Palo Verde Nuclear
Generating Station

**Subject: Palo Verde Nuclear Generating Station (PVNGS)
Units 1, 2, and 3
Docket Nos. STN 50-528, 50-529, and 50-530
Request for Amendment to Technical Specification 4.2.2, Control
Element Assemblies**

Evaluation of the Proposed Change

Figure 1
Comparison of Ag-In-Cd and Compression Sleeve CEA
Tip Designs

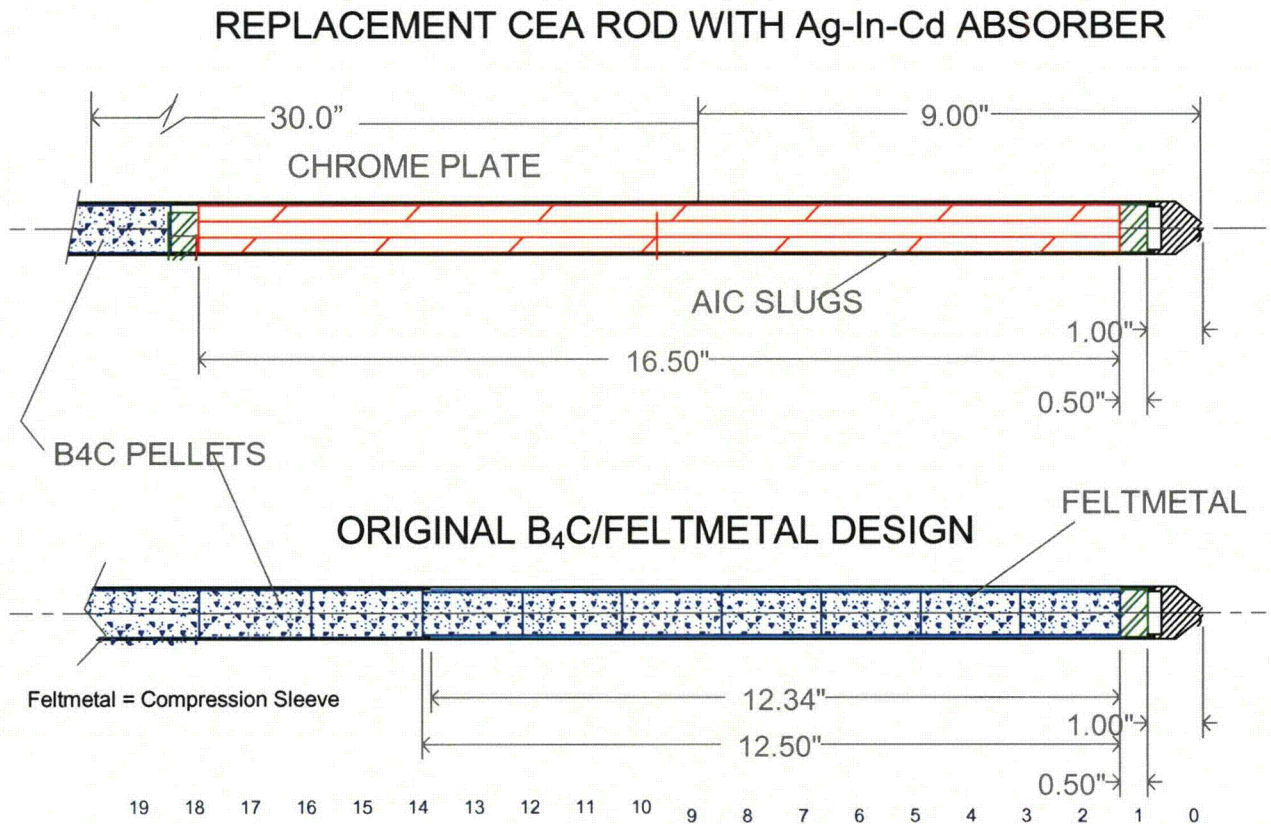
The fingers of the current full-strength CEA consist of an Alloy 625 tube loaded with a stack of cylindrical absorber pellets. The absorber material consists of 73% theoretical density (TD) B₄C pellets, with the exception of the lower portion of the fingers, which contain reduced diameter B₄C pellets wrapped in a compression sleeve of type 347 stainless steel. The purpose of the compression sleeve is to prevent infiltration of B₄C fines (free B₄C powder) into the pellet/clad gap preserving room for pellet swelling and to compress allowing the pellet to swell while limiting cladding strain. This is shown in Figure 1.

Figure 2
Chrome Plated Zone to
Primary Contact Region with Post Exit

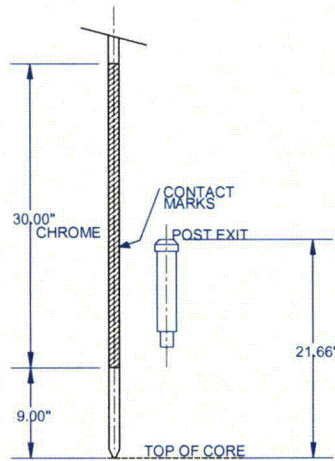
The replacement Ag-In-Cd full-strength CEAs have a lifetime of approximately 11 EFPY as opposed to a lifetime of 8 EFPY for current compression sleeve full-strength CEAs. To assure that the Alloy 625 cladding is capable of supporting the increased lifetime without violating established wall thinning criteria, the Ag-In-Cd full-strength CEAs will have chrome plating, as shown in Figure 2, applied to the outside diameter in the area expected to contact the fuel assembly upper guide posts when the reactor is operating in an essentially unrodded condition, or during normal maneuvering within the Power Dependent Insertion Limit (PDIL). Westinghouse has determined that application of

chrome plating to the Alloy 625 cladding will allow the Ag-In-Cd full-strength CEAs to remain parked in one position for the entire design life without violating wall-thinning criteria.

Figure 3
Spider with Chamfered Boss

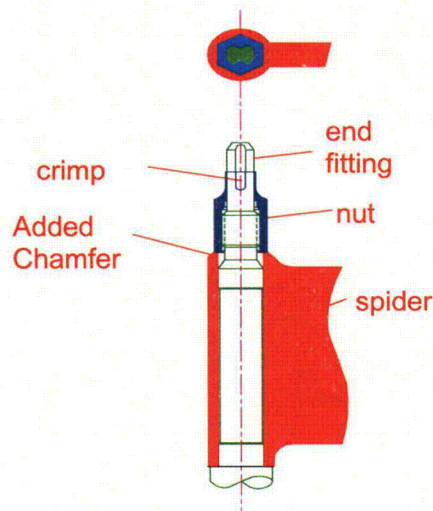
Additionally, the upper edges of the spider bosses have been chamfered, as shown in Figure 3, to prevent damage to the self-latching mechanisms that can occur if the CEA hangs up when lifting through the upper guide structure cut outs. This change is for ease of maintenance and has no impact on operation of the CEAs.
